### **REMARKS**

### **Drawings**

Enclosed are nine (9) red-inked Drawing Annotated Sheets including various corrections to improve accuracy.

*Fig. 1*

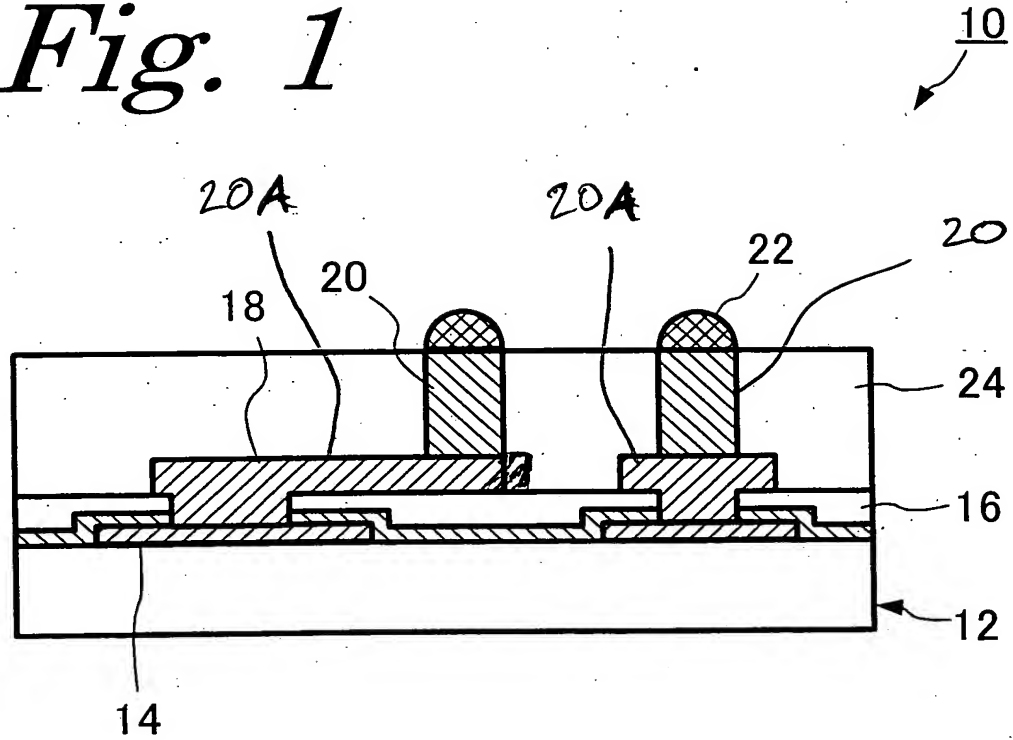
Particularly, as may be readily understood in view of original Fig. 1 and as described on page 8 of the application as originally filed, terminal 22 is shown as on top of conductive post 20, whereby conductive post 20 is formed on conductive wiring pattern 18. However, original Fig. 2, which shows a top plan view of the structure in Fig. 1, includes conductive post 20 as having a diameter much larger than terminal 22, contrary to Fig. 1. In other words, since terminal 22 is located on and covers conductive post 20, conductive post 20 should not be seen in the top plan view of Fig. 2. The original figures thus include incorrectly denoted reference numerals.

Additionally, Fig. 1 has been corrected to show conductive portion 20A as extending in a horizontal direction beyond the vertical edge of conductive post 20. This additional correction of Fig. 1 should be self-evident and clearly supported in view of original Fig. 2.

Accordingly, Figs. 1 and 2 for example have been corrected to include conductive portions 20A, which can be seen in the top plan view of Fig. 2 in particular as having a diameter that is greater than the diameter of terminal 22. Since terminal 22 is located on and covers conductive post 20, conductive post 20 is not shown in corrected Fig. 2. However, to improve understanding, the terminal is denoted in
